REGIONAL REVIEW NOTIFICATION

ARC REVIEW CODE: R1710231

Name of Proposal: South Lawn Mixed Use Development (DRI 2727)

DRI SITE PLAN

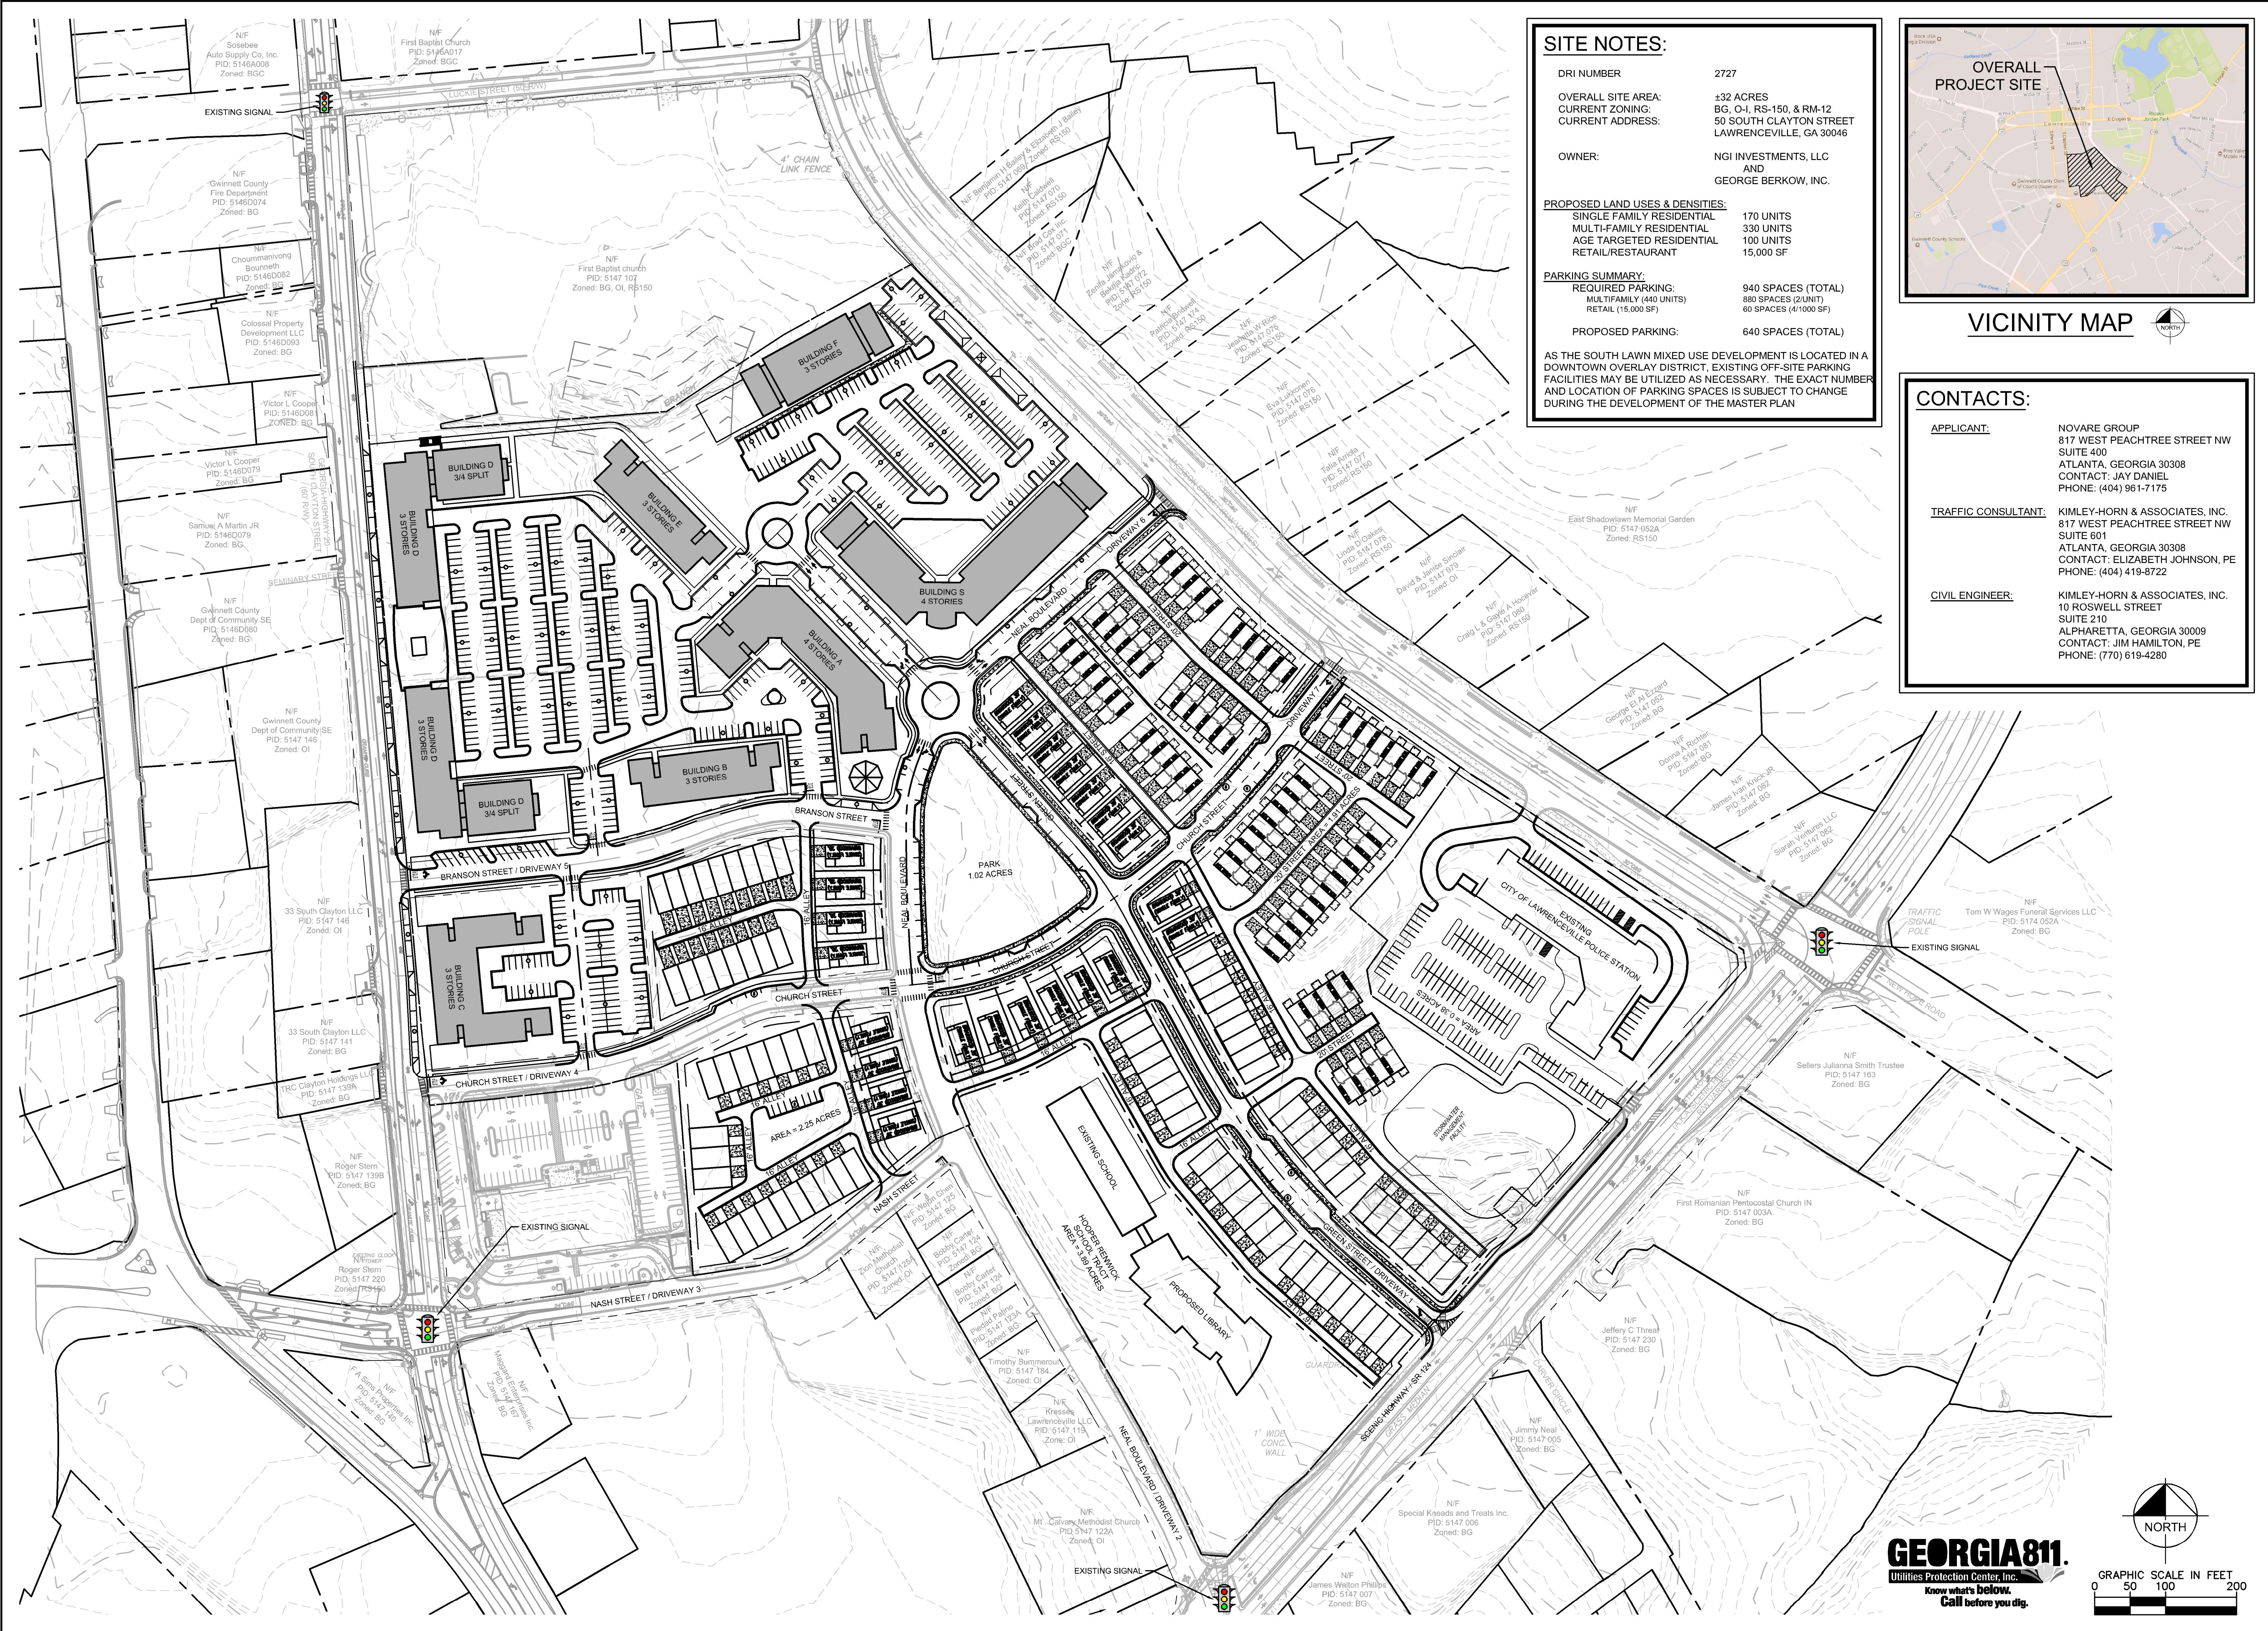
The USGS coverage for the shows an intermittent (dashed blue line) stream that is a tributary to Shoal Creek, which in turn is a tributary to the Alcovy River, running southward from the property. The site plan does not identify a stream, but it does show what appears to be stream channel in the eastern portion of the site, with proposed construction over the channel and a proposed stormwater management facility along the property’s frontage on Scenic Highway/SR 124. The City will need to determine if the proposed project is subject to the Part 5 water supply watershed buffers, as well as the City’s stream buffer ordinance, which requires a 50-foot undisturbed buffer and an additional 25-foot impervious surface setback. In addition, all waters of the State on this property are subject to the State 25-foot Sediment and Erosion Control Buffer. No buffers are shown on the site plan. Any intrusions into the applicable water supply watershed and City stream buffers may require a variance, as will intrusions into the state 25-foot Erosion and Sedimentation buffer. Any unmapped streams on the property may also be subject to the requirements of the County stream buffer ordinance. Any unmapped state waters on the property will also be subject to the State 25-foot Erosion and Sedimentation buffer requirement.

The proposed development includes local road connectivity between parcels internal to the site, however proposed access points do not align with existing access points for adjacent development causing conflict points. Examples include, Drive access #4 on Church Street and Access point 5 on Branson Street. Driveway access points along major thoroughfares for existing development opposite the site were not provided.

In the interest of safety, the location of access points proposed should be aligned with existing site access points of adjacent developments. This will decrease the number of potential conflict points as identified in item #9.
